DESCRIPTION: Ltr re our 6-13-75....trans the following: <u>DIST PER LA WILSON</u>	ENCLOSURES: Info concerning secondary system fluid flow instability in the Diablo Canyon design.... (15 cys encl rec'd)
PLANT NAME: Diablo Canyon 1 & 2

Diablo Canyon Units 1 and 2

Secondary System Fluid Flow Instability

Information Requested By NRC Letter Dated June 13, 1975

PIPING ISOMETRIC DIAGRAM
FEEDWATER PIPING TO STEAM GENERATORS

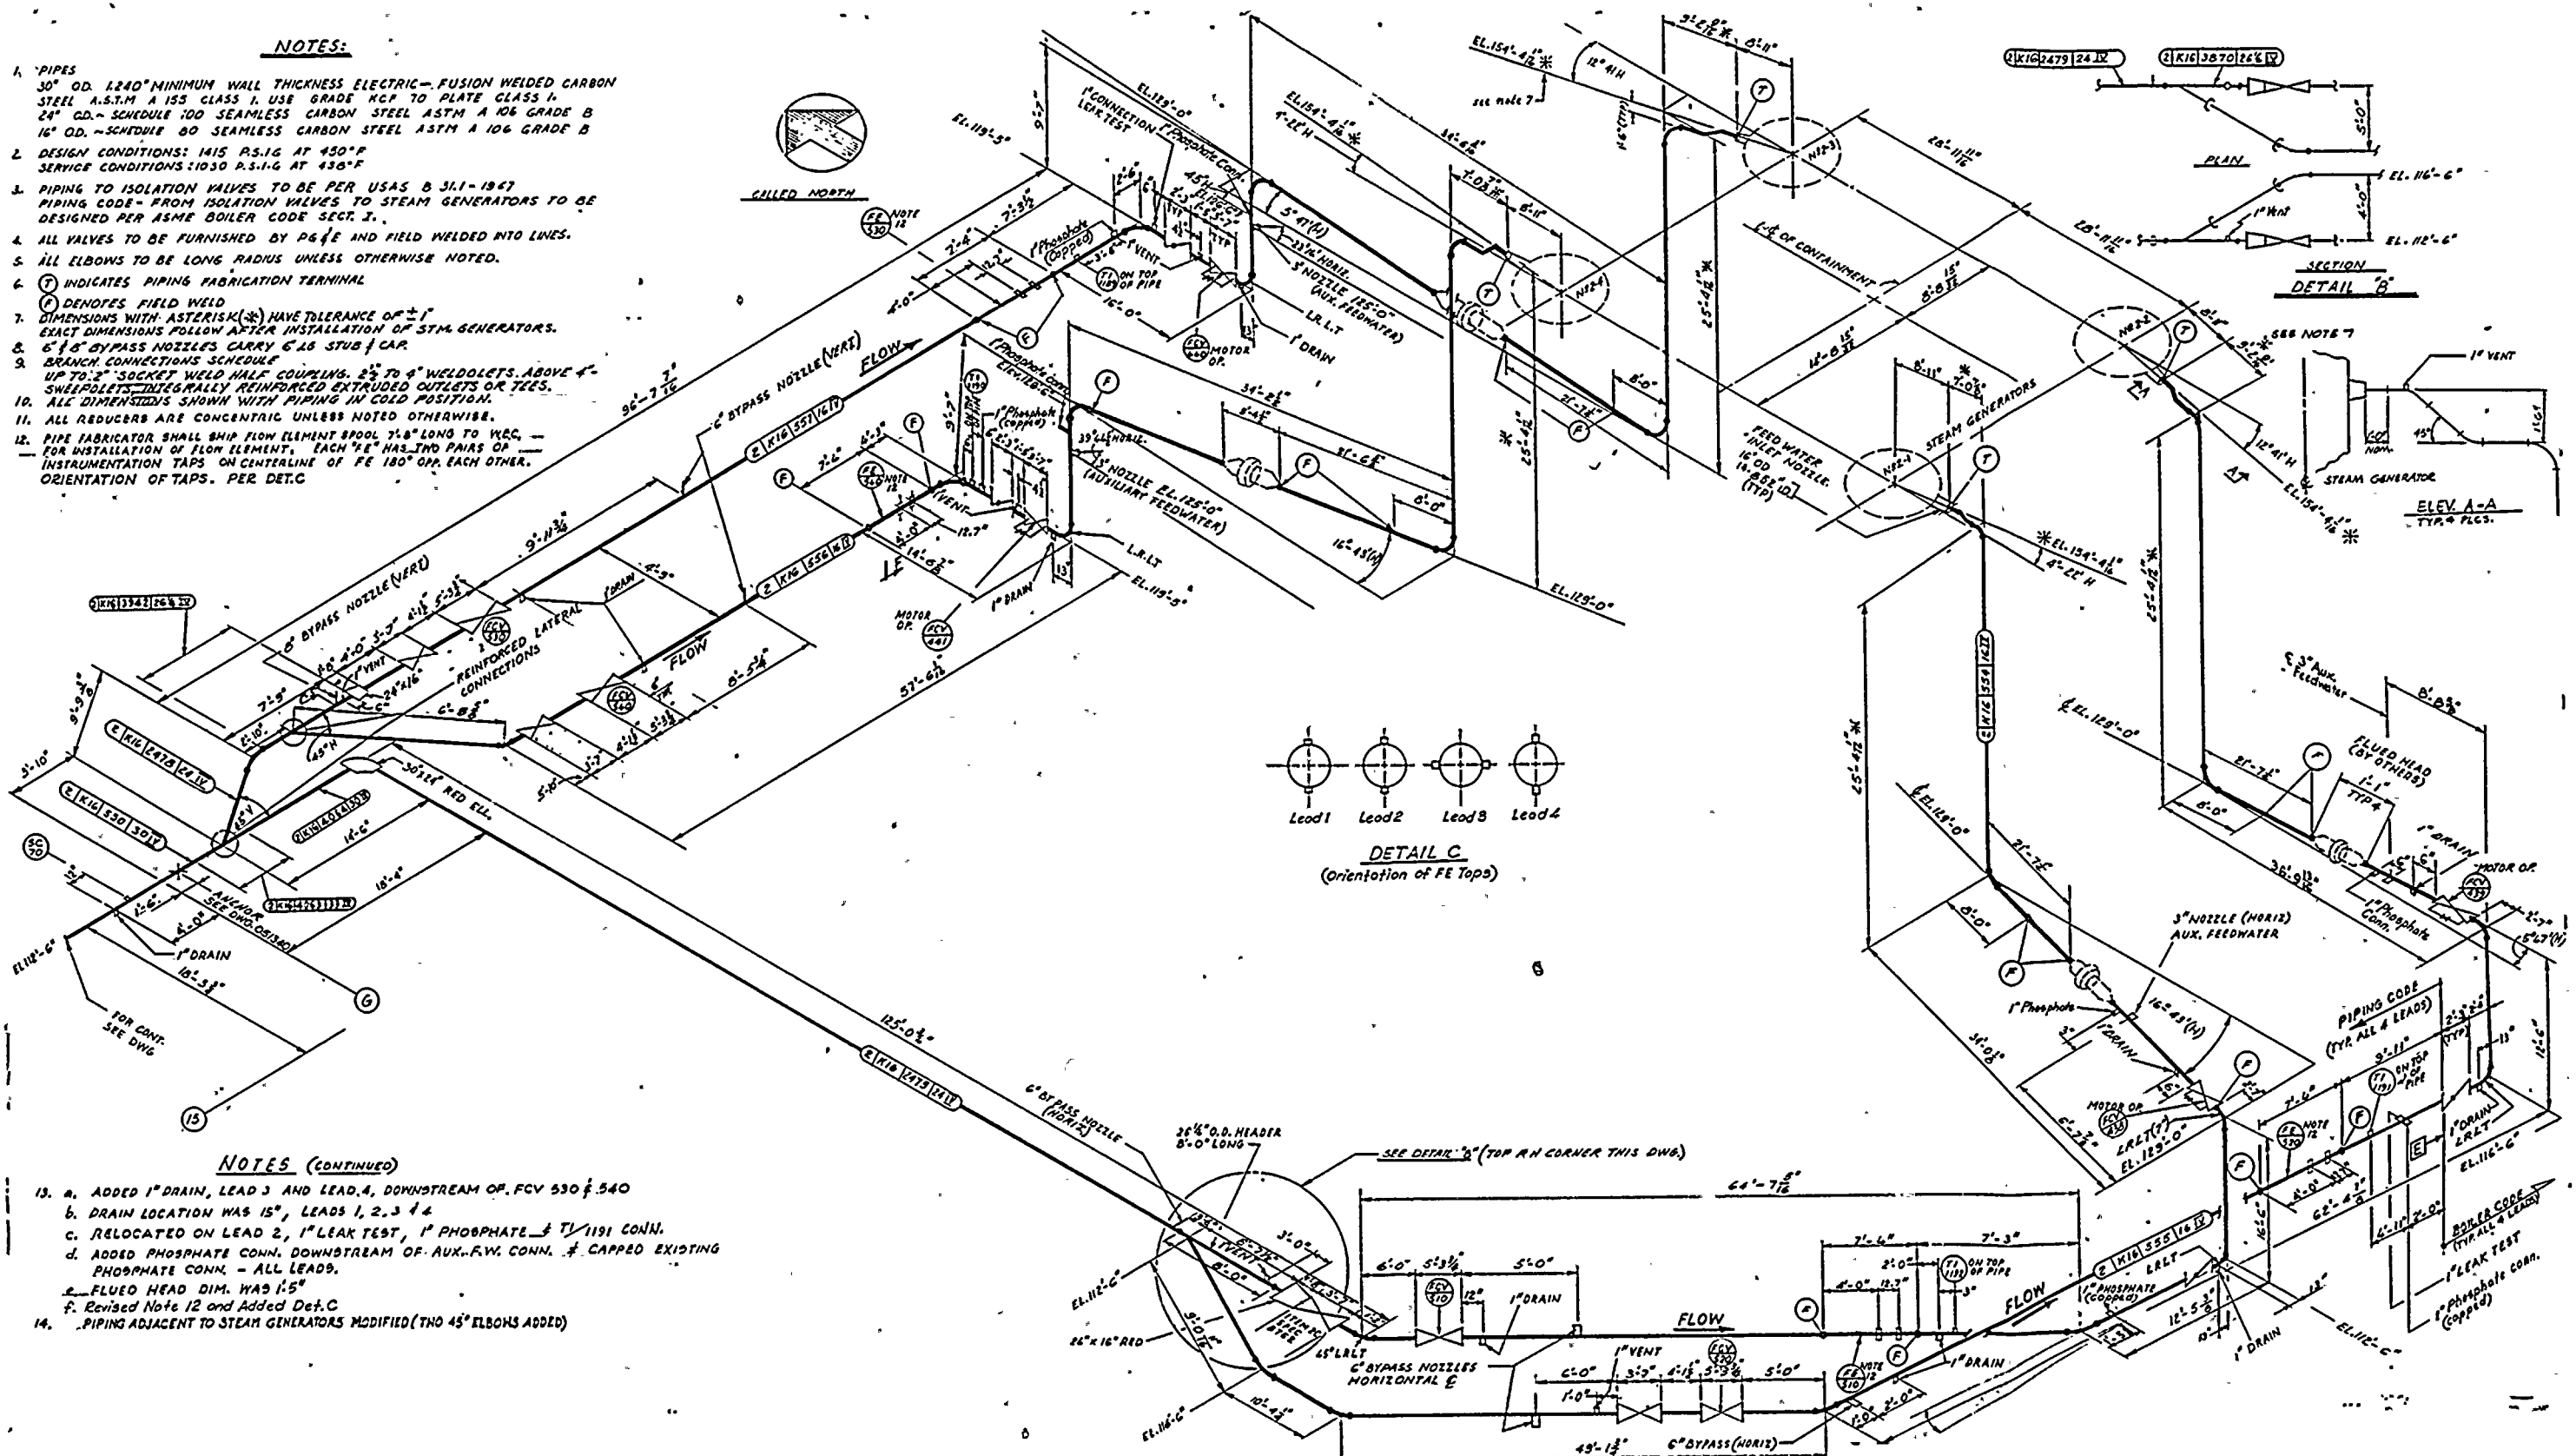
Question 2. Describe and show by isometric diagrams, the routing of the main and auxiliary feedwater piping from the steam generators outwards through containment up to the outer isolation valve and restraint. When describing the piping run, note all valves and reference continually, the elevation of the inlet nozzles and/or sparger with respect to the piping run elevation.

Response: Isometric diagrams of the routing of the main and auxiliary feedwater piping from the steam generators outwards through containment up to the outer isolation valve and restraint are attached. A schematic drawing indicating the supports and restraints for a typical feedwater line is attached also. The feedwater piping leaves all steam generators at a nominal elevation of 154'-4 1/16". One foot horizontally from the steam generator feedwater nozzle, the lines turn downward with 45° elbows. After passing downward at a 45° angle for approximately 5½ inches of pipe, the lines return to the horizontal thru a second 45° elbow. The lines are now at elevation 152'-10½", approximately 18 inches below the inlet nozzles. This portion of the lines pass thru the crane wall. The lines continue horizontally until they turn downward at 90° elbows. The vertical run of pipe is 8 feet 8 inches from the steam generator shell for steam generators 1 and 4 and 10 feet 9 inches from the steam generator shell for steam generators 2 and 3.

13. a. ADDED 1" DRAIN, LEAD 3 AND LEAD 4, DOWNSTREAM OF FCV 530 & 540
- b. DRAIN LOCATION WAS 15", LEADS 1, 2, 3 & 4
- c. RELOCATED ON LEAD 2, 1" LEAK TEST, 1" PHOSPHATE & T/1191 CONN.
- d. ADDED PHOSPHATE CONN. DOWNSTREAM OF AUX.-R.V. CONN. & CAPPED EXISTING PHOSPHATE CONN. - ALL LEADS.
- e. FLUED HEAD DIM. WAS 1.5"
- f. Revised Note 12 and Added Det. C
14. PIPING ADJACENT TO STEAM GENERATORS MODIFIED (THO 45° ELBOWS ADDED)
